Project: 25-061-00 / BGS 3831

Subject: Addendum 01 - Narrative

Subject: BID RFI Responses – (Comprehensive)

CMCC HEALTHCARE TRAINING EXPANSION

CONTENT:	FIRST FLOOR DEMOLITION PLAN
DRAWN BY:	NMS
PROJECT NO:	25-061-00
DATE:	04/24/26
REVISED:	
SCALE:	As indicated

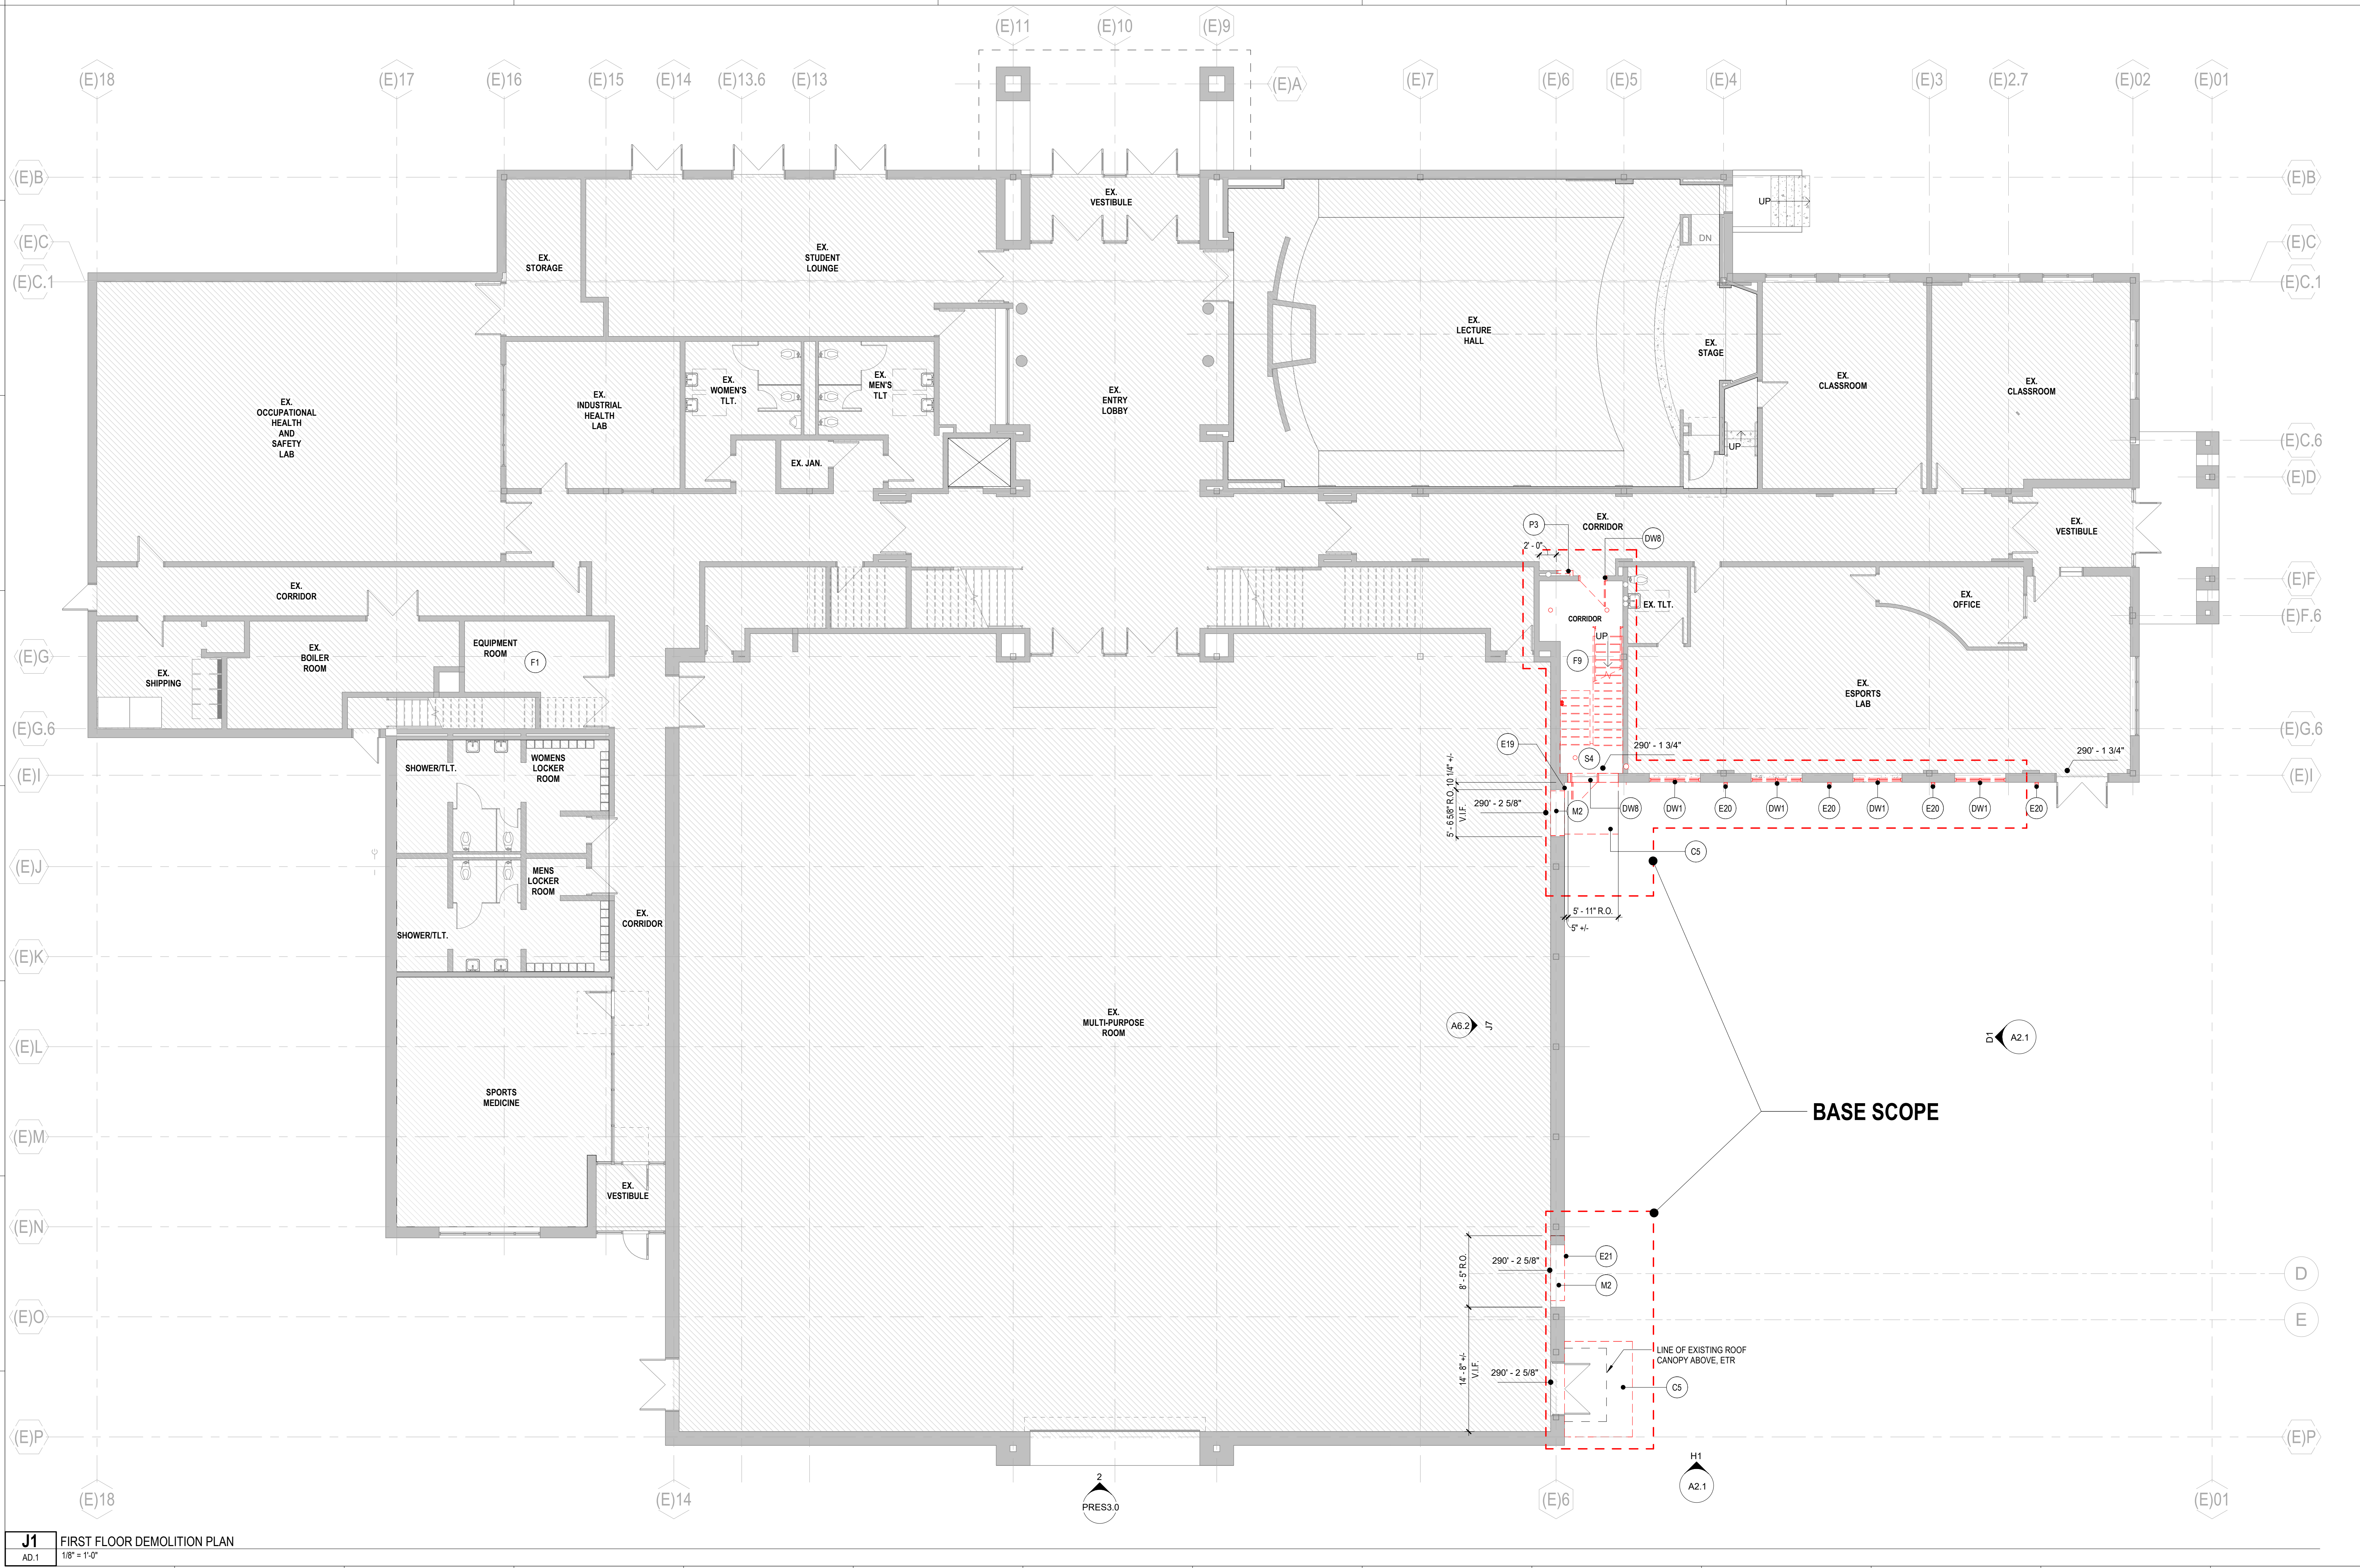
Drawing AD.1 has a demo note P3 in the existing corridor. There is no demo note P3 identified in the demo legend.	This note is part of the existing partitions to be demolished schedule of notes and was cut off in error. P1,P2,P3 will be included in Addendum 01.
Will the existing Multi-Purpose room be in full use during construction? Are there limitations on when the work at the exterior wall can be done?	I assume this question refers to the gym. Yes the gym will be in use during construction. Most of the events will be during evenings or on weekends. Currently, Women's Basketball, Men's Basketball, Men's JV Basketball, and Women's Volleyball hold home games in the gym. Occasionally, there will be games and events during business hours that will limit the work that can be done.
Will the GC be allowed to have a field office in the existing building or will a site office be required?	There will not be an office available in the building. I assume a site office will be needed if the GC wants a space .GC to provide temp facilities as specified.

H8 RCP ACT/GWB SOFFITS/COVE LIGHT
A8.1 1" = 1'-0"

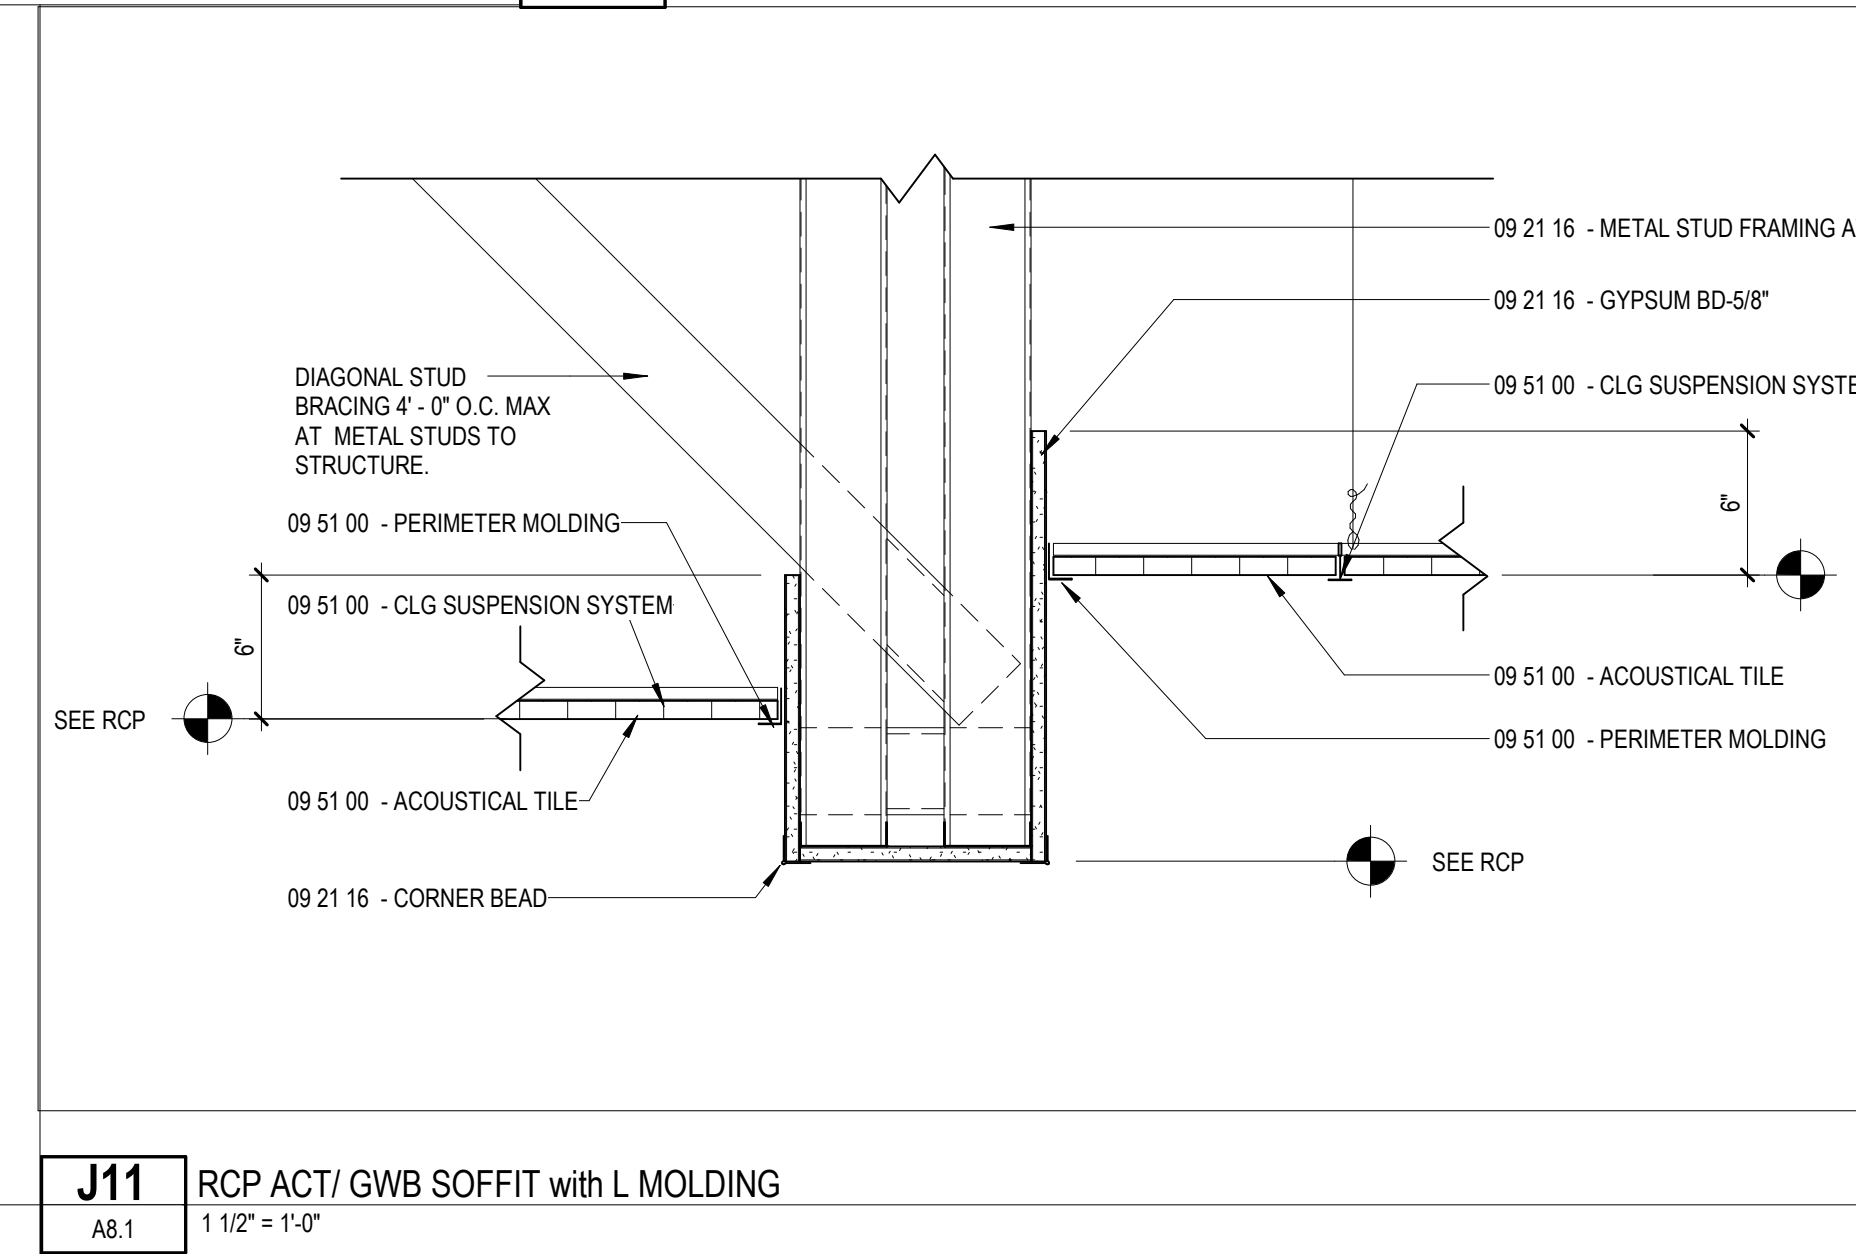
- 1. Trim Type:
 - a. Vertical type unless otherwise indicated.
 - b. Provide knife-edge light cove profile at locations indicated on Detail H8/A8.1.
 - 1) Product: AXIOM Knife Edge for ACT by Armstrong World Industries. [Addendum 01].
